**RE: MODIFICATION to Stream Alteration Permit Application 15-99-01SA**

# Stream Alteration Permit Application Modification 1

Photograph 3 Channel Upstream of the Road (12/2015)

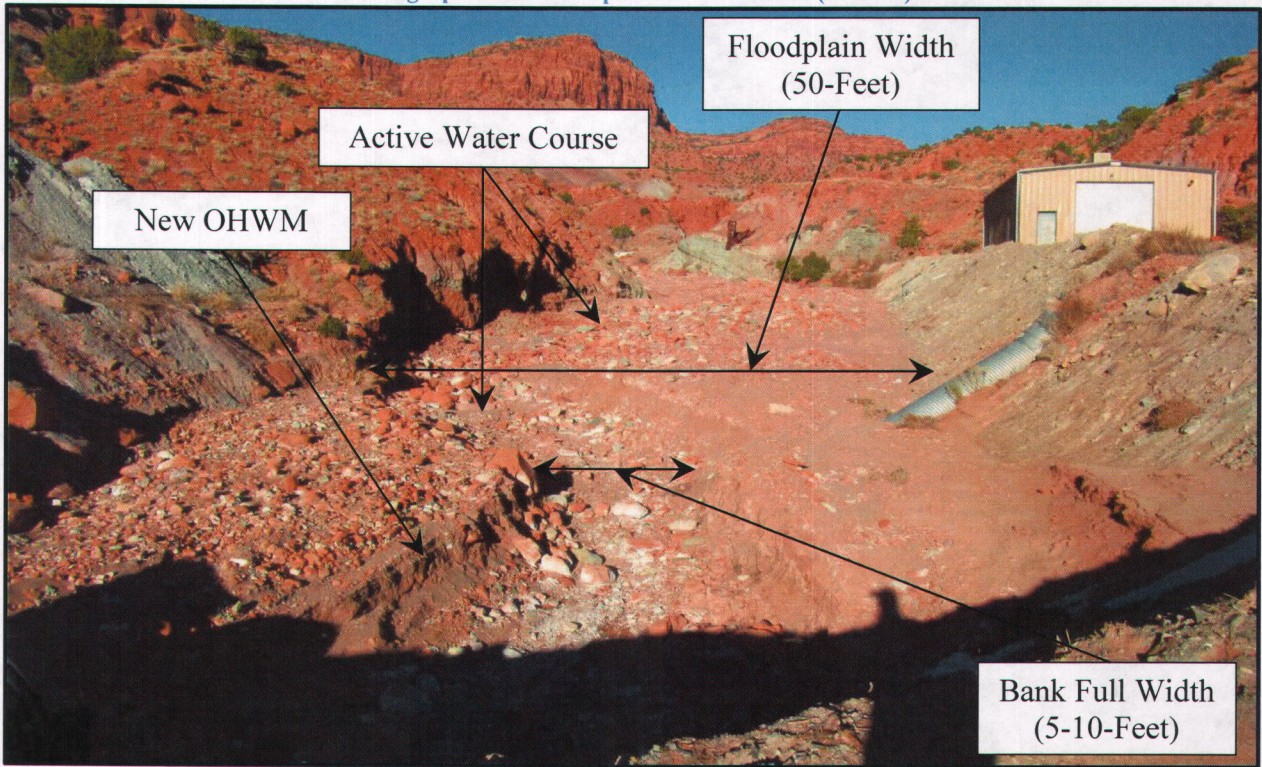
2. *A more detailed cross-section view showing the stream and adjacent features, approximate dimensions, and ordinary high water.*

4. *The Corps has indicated that the applicant needs to provide a plan view with the project area outlined (area where actual impacts will occur) on a scale that can clearly show the location of the Ordinary High Water Mark (OHWM) and impacted areas. On the plan view include: 1) OHWM, north arrow, scale; 2) Amount of permanently impacted area below OHWM (and temporary impact areas, if any); and 3) Fill amounts below OHWM (in this case, the amount of fill/rocks moved from one location to another if both are below OHWM). Also please provide a cross-section view of the impacted area on the stream bank, with the impacted area and OHWM depicted. For more information, Jon Boe, of the Corps, can be contacted at 435-986-1961 or at [Jon.R.Boe@usace.army.mil](mailto:Jon.R.Boe@usace.army.mil).*

Map 3 was revised to incorporate the requested information. Photographs 3 and 5 were annotated to include this information. Map 4 was provided to show the proposed culverts.

Maps 2, 3 and 4 incorporate the requested information. Photograph 3 was also annotated to include this information. The impacts to the area below the OHWM include:
